LiDAR Quality Assurance (QA) Report

QA Report for Oahu LiDAR

Produced for National Oceanic and
Atmospheric Administration

Report Date: May 16, 2014

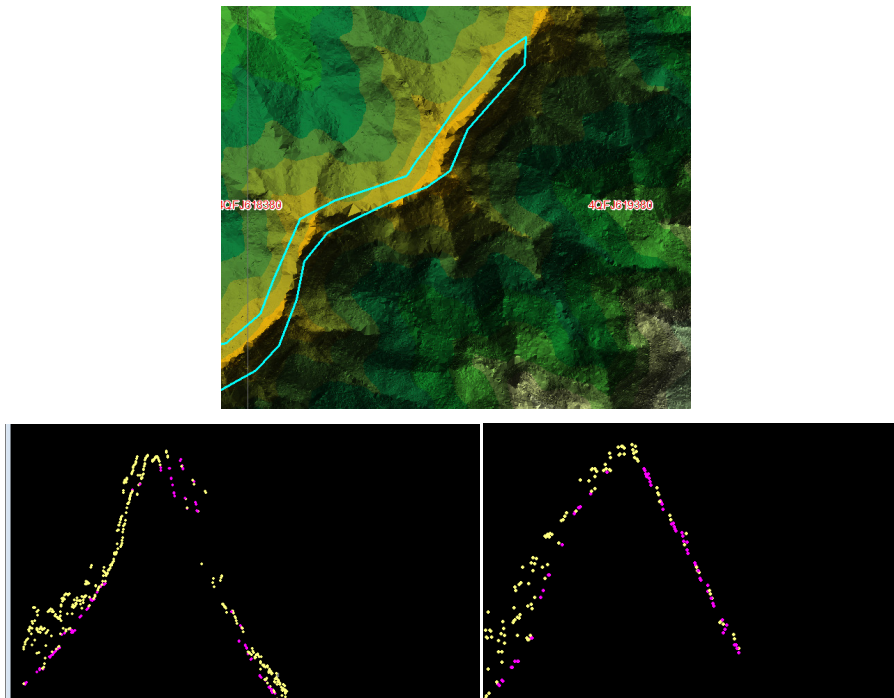
Aggressive Misclassification

Aggressive misclassification calls in this document imply that LiDAR points are unclassified in the delivered dataset when they should be classified to ground. This call indicates areas where some class 1 points could be reclassified to class 2, ground, to improve detail in the surface model and to more correctly model surface features. There are nine (9) instances of aggressive misclassification identified in this project area. An example of aggressive misclassification edit calls is found below and a geodatabase that contains the locations of all edit calls accompanies this report. The majority of these calls have been placed on the tops of ridges where points are present that would represent the peaks.

All areas marked for revisions have been addressed. While some minor misclassification still exists on the very tops of ridges they are within the 2% requirement for incorrectly classified data.

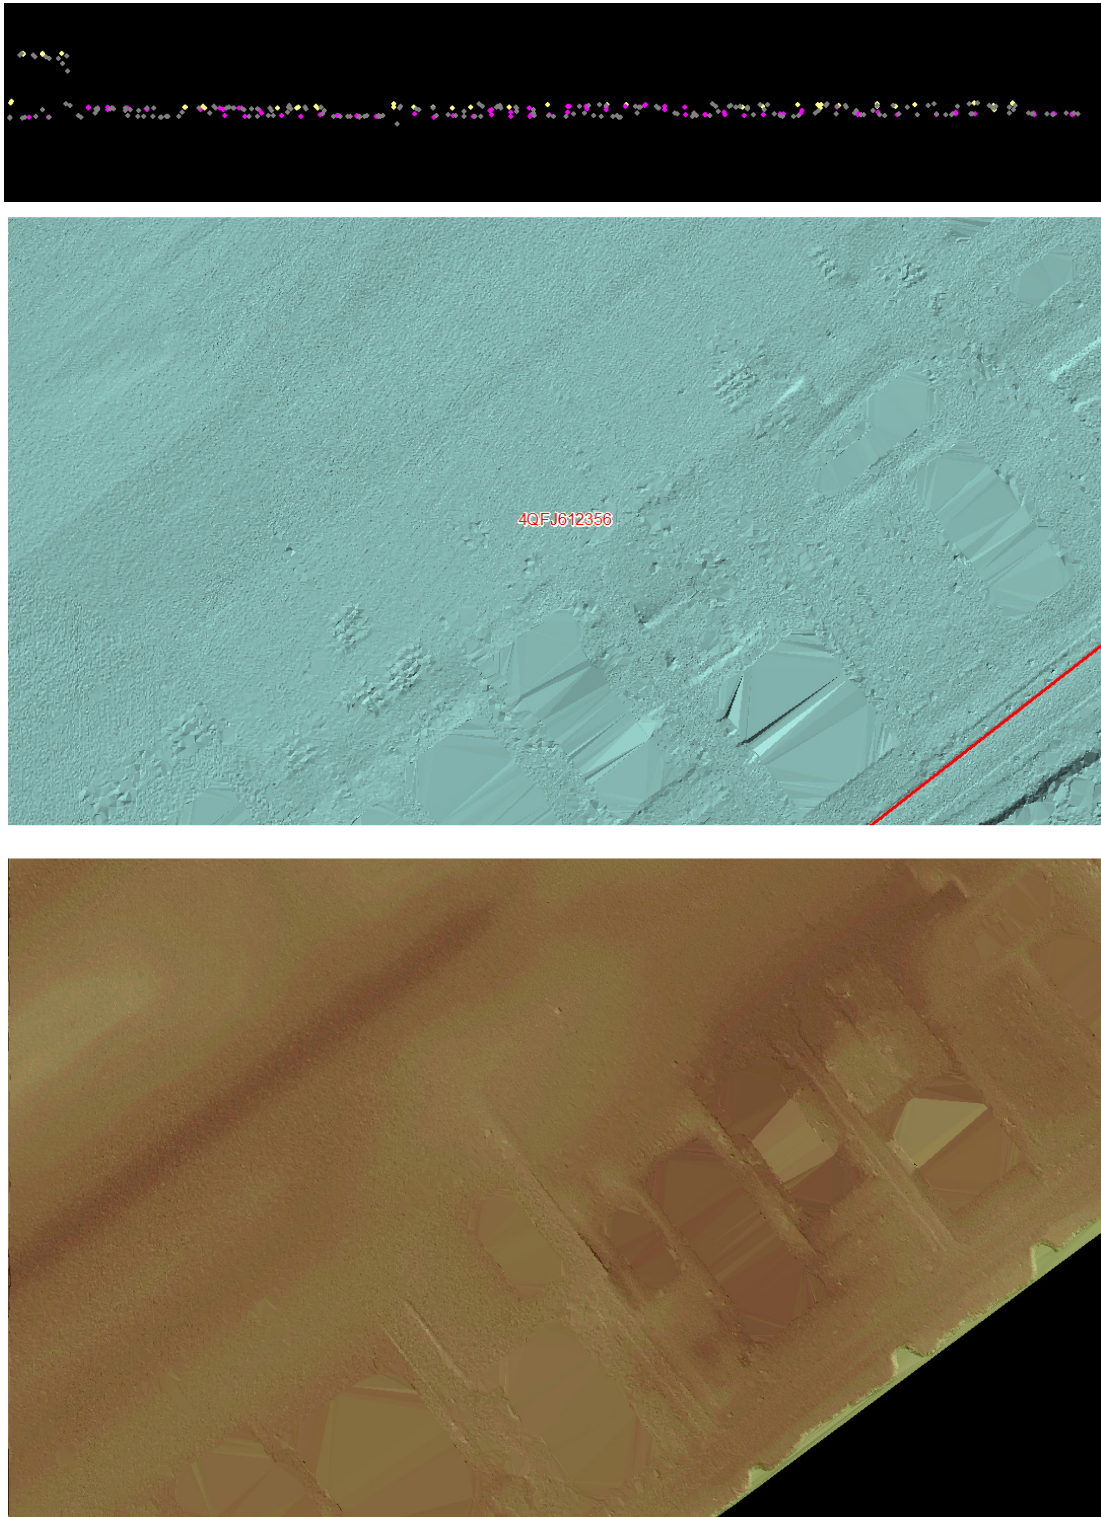
Artifacts are features that are left in the ground model that should be removed. There are five (5) artifacts identified in the project area and include bridges and structures. Vegetation has been separated out into a separate class for this project as the majority of issues were related to vegetation artifacts. These should be removed in order to improve the bare-earth surface model. Examples of artifact edit calls can be found below and a geodatabase that contains the locations of all edit calls accompanies this report.

All artifacts have been sufficient resolved.

Figure 7 – Tile 4QFJ624365. Example show visible corn row effect throughout this tile and surrounding area. The bottom image shows that the corn rows have been corrected.

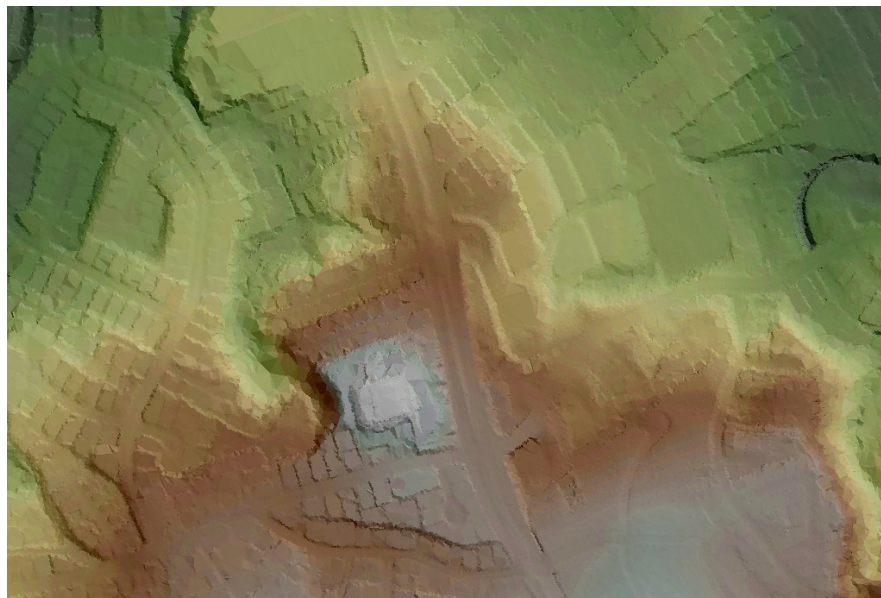
One area within the project area exists where corn rowing is prevalent throughout the area and is visible at the review scale. The extents of this area have been outlined in the LAS edit calls polygon. The edges of this area are also visible with a sharp change in elevation and overall LiDAR smoothness.

The issue regarding corn rows has been resolved and is no longer present in the dataset.

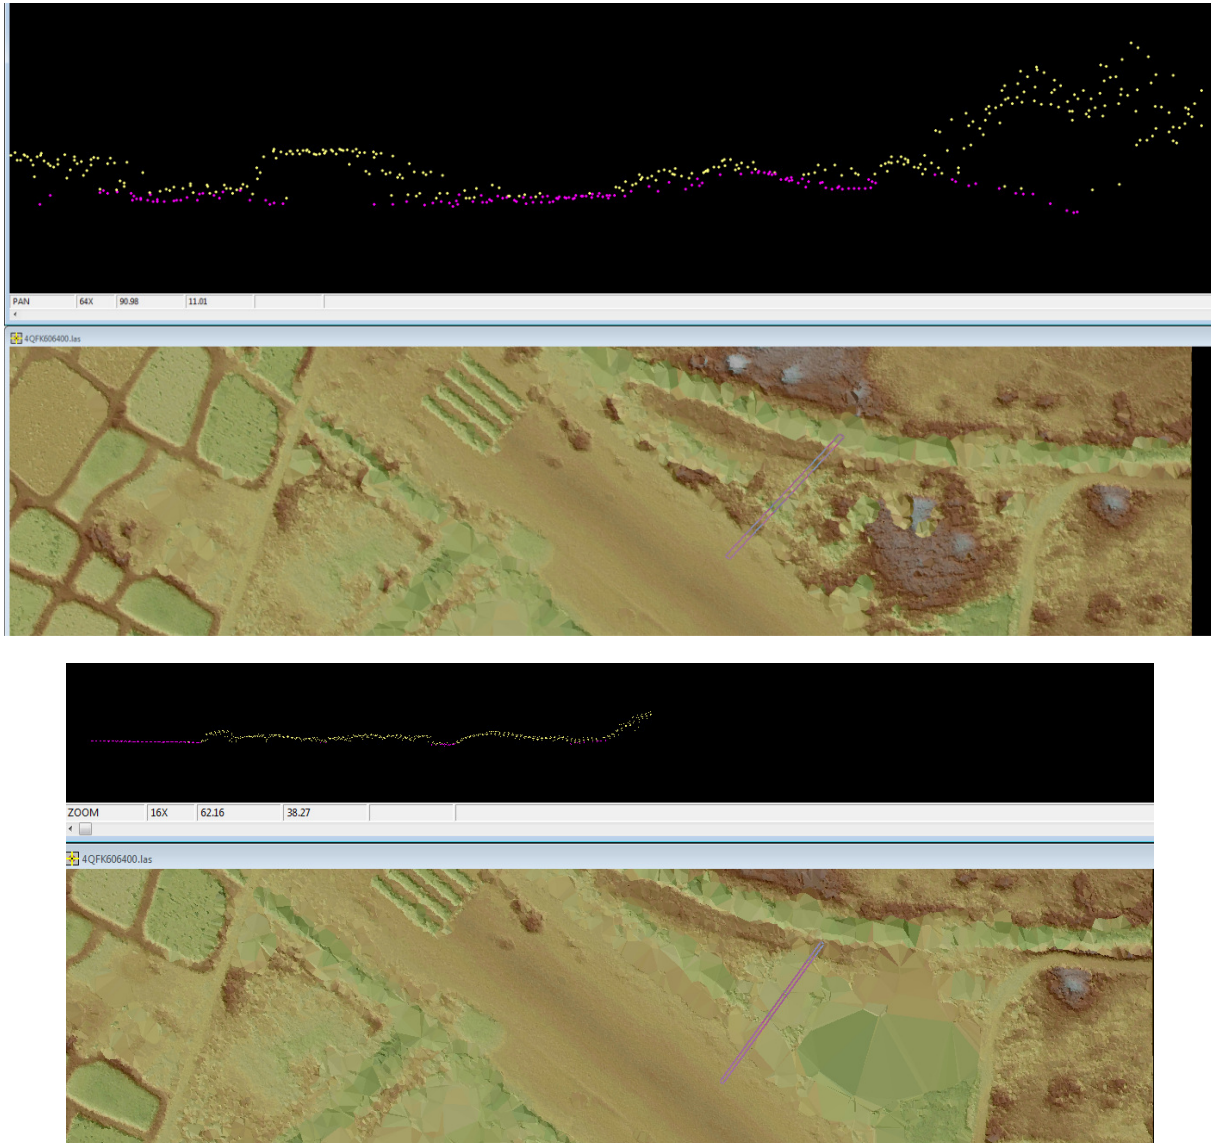
Vegetation artifact calls in this document imply that LiDAR points are incorrectly classified in the delivered dataset and should be re-classified to class 1 (unclassified). There are 123 instances of vegetation artifacts identified in this project area. Because this issue was prevalent in the dataset polygon edit calls were placed in areas where the issue was most visible.

All vegetation artifacts have been sufficiently addressed. In some cases minor vegetation does remain in the ground but based on input from NOAA CSC the limited vegetation was acceptable and does not negatively impact the use of the data.
